PJ3307-1  
**Fire Prevention**  
In: 10/04/2018  
Out: 10/05/2018  
Please maintain emergency access during construction work.

## RCRBD Record Set

An Entry Remodel for  
**STEAMBOAT GRAND**  
2300 MT. WERNER CR  
STEAMBOAT GRAND RESORT HOTEL CONDOMINIUM  
STEAMBOAT SPRINGS  
ROUNTY COUNTY, COLORADO

SHEET TITLE:  
ENTRY VESTIBULE PLANS,  
ELEVATION(S), DETAIL(S)

3 ENTRY PLAN (NEW)  
SCALE: 1/4" = 1'-0"

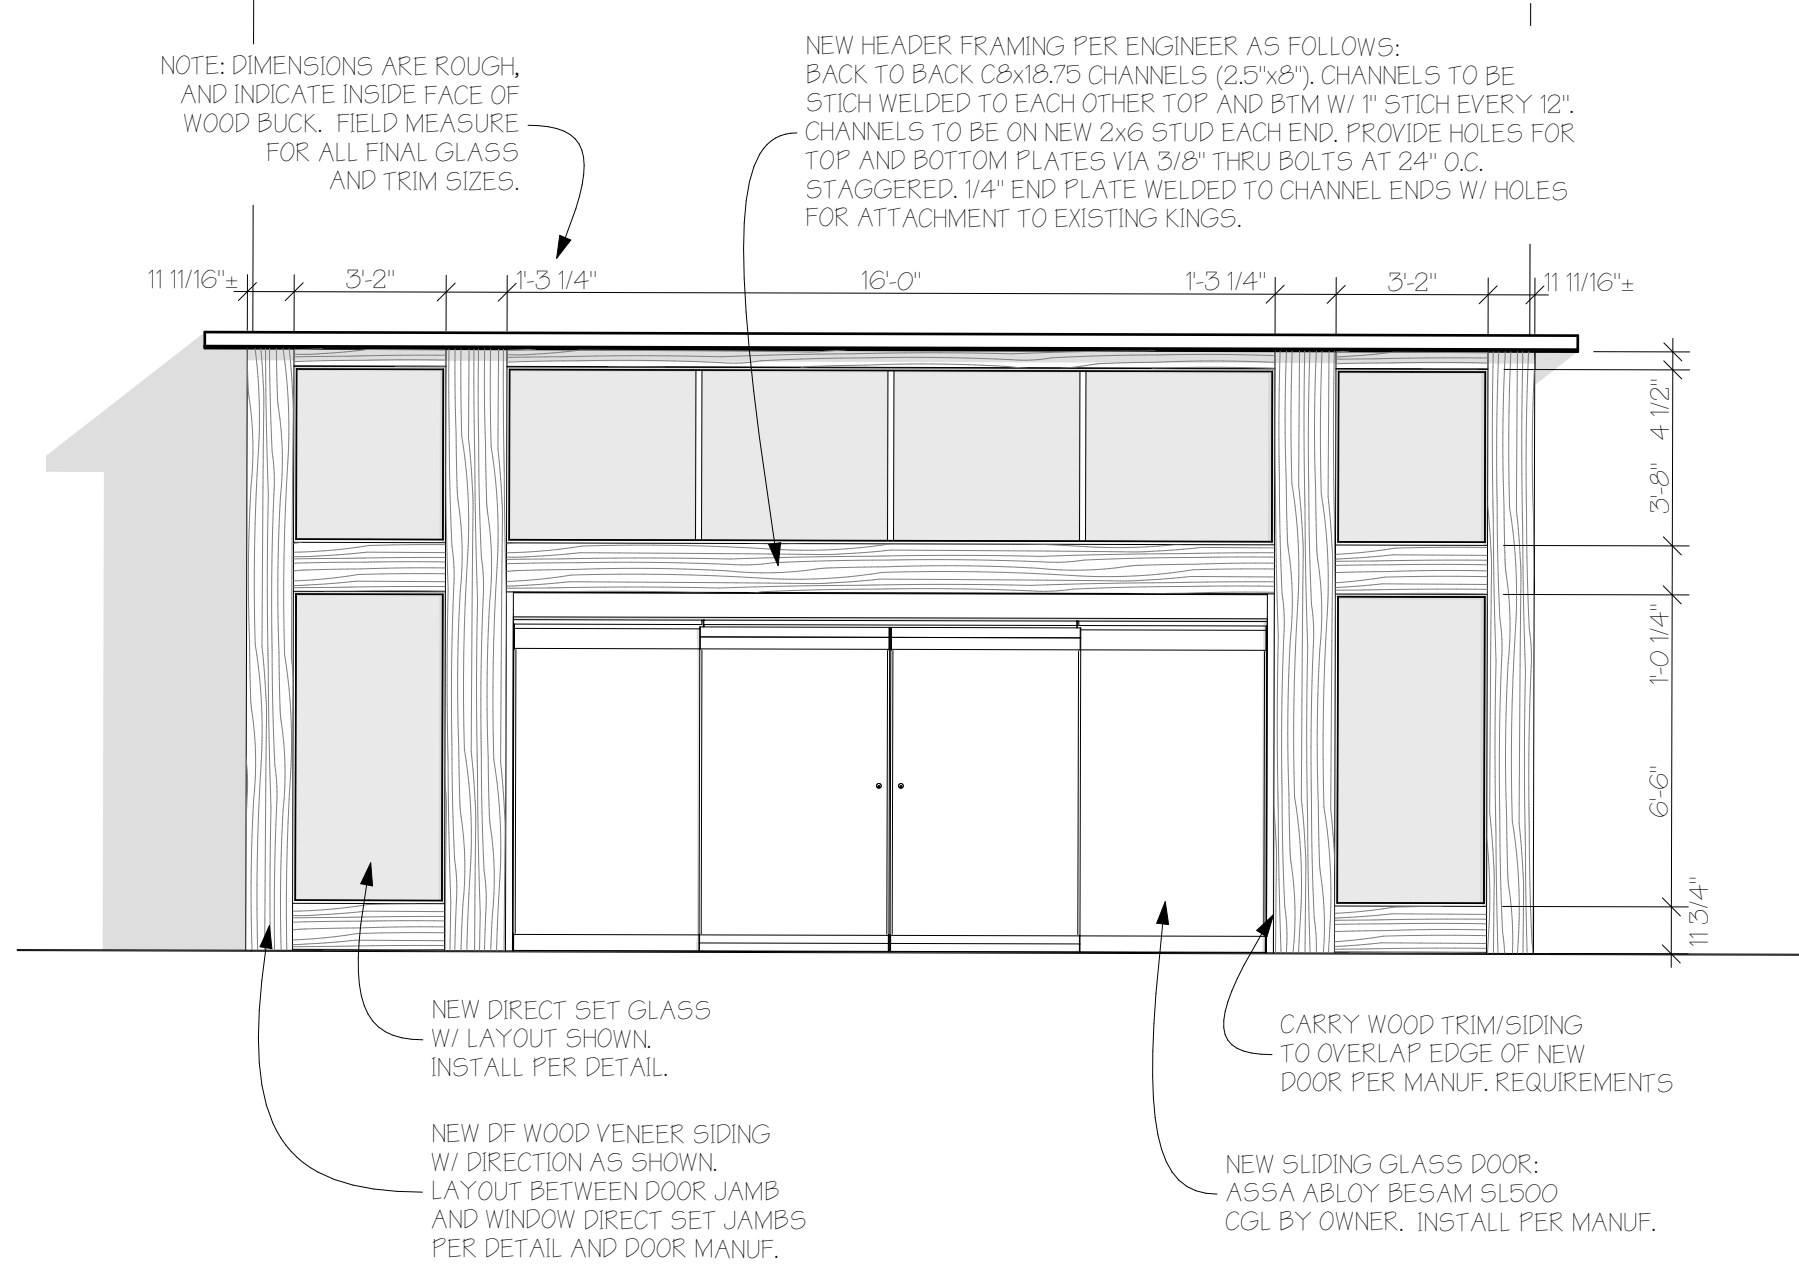
1. New Doors and Windows to meet the U-Factor to meet C303.1.3(1) and C303.1.3(2) : Sticker to be kept on windows for inspection
2. IBC Section 1010.1.4.2 Sliding Doors to meet 50# Breakout Force, have door specifications on-site for inspections.
3. New tile floor shall meet ADA compliance per ICC A117.1-2009 Chapter 3.
4. Glazing as required per IBC Section 2406.
5. Special Inspections done per IBC 1704.2.5 for Stitch Welding unless exceptions or certifications are met.
